THE HIGHLINE AT UNION MARKET

320 FLORIDA AVENUE, N.E.
WASHINGTON DC

March 25, 2016
PUD MINOR MODIFICATION FOR PUD 15-01

ROOF PLAN - APPROVED & PROPOSED

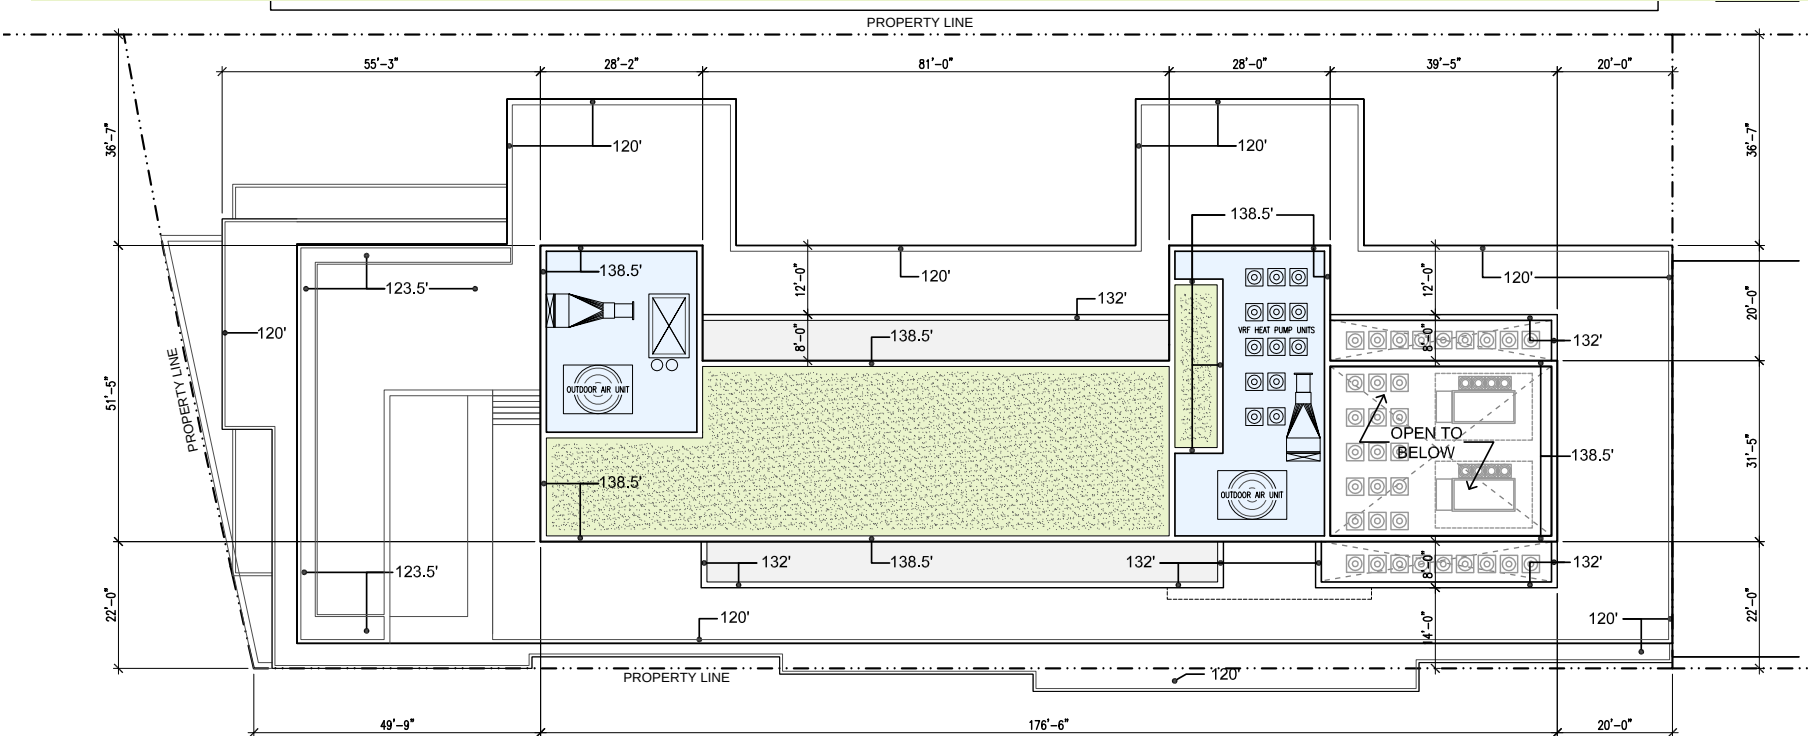
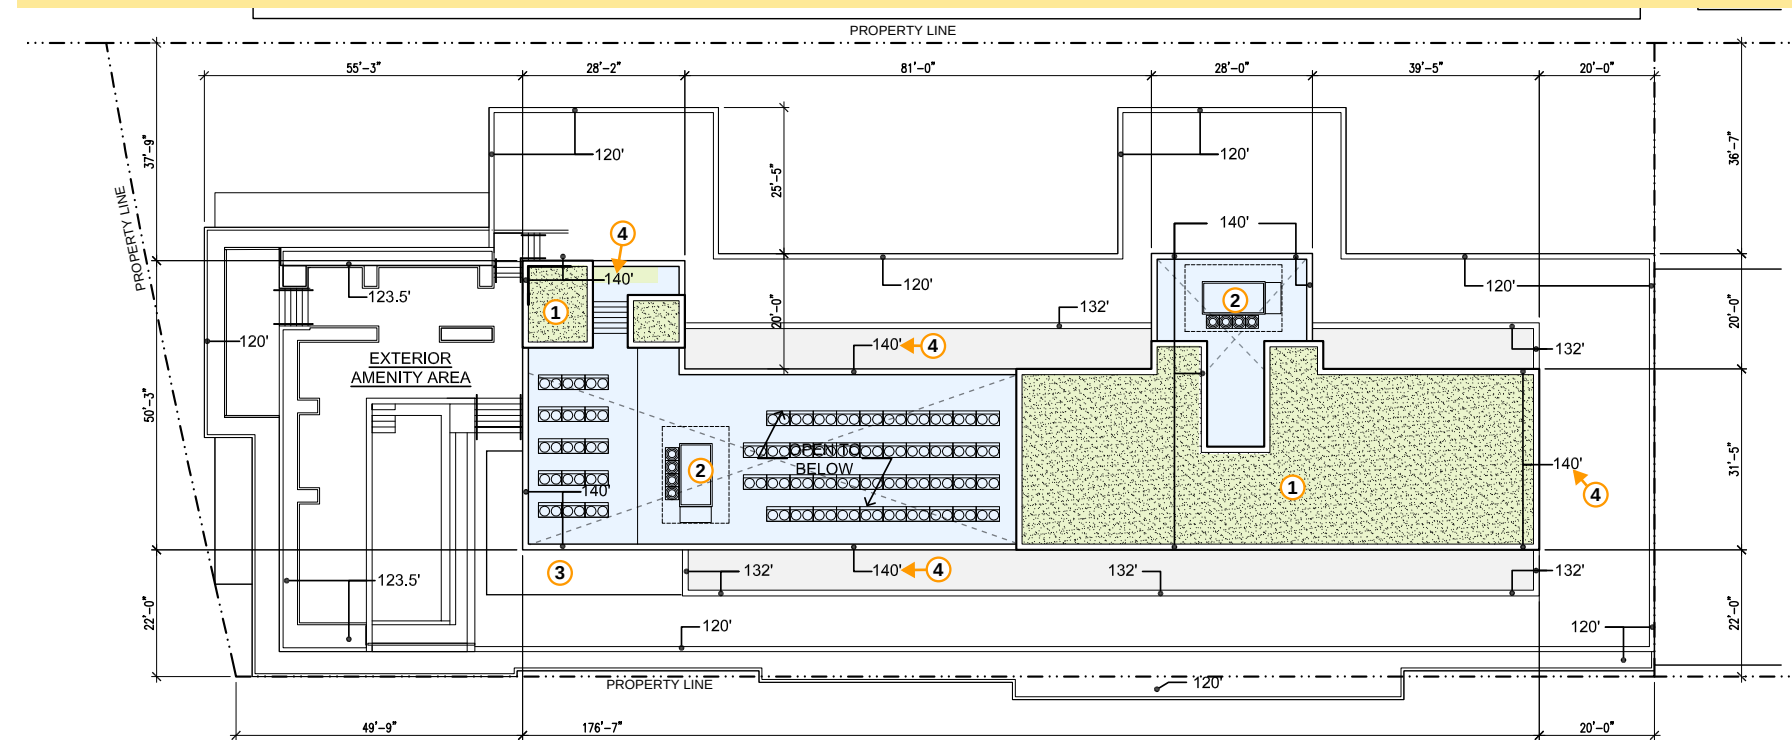
- * CHANGES TO ROOF STRUCTURE TO INCORPORATE ZC ORDER NO. 14-13
- 1. NEW GREEN ROOF LOCATION
- 2. NEW MECHANICAL EQUIPMENT LOCATION
- 3. NEW TREILLIS
- 4. NEW PARAPET HEIGHT
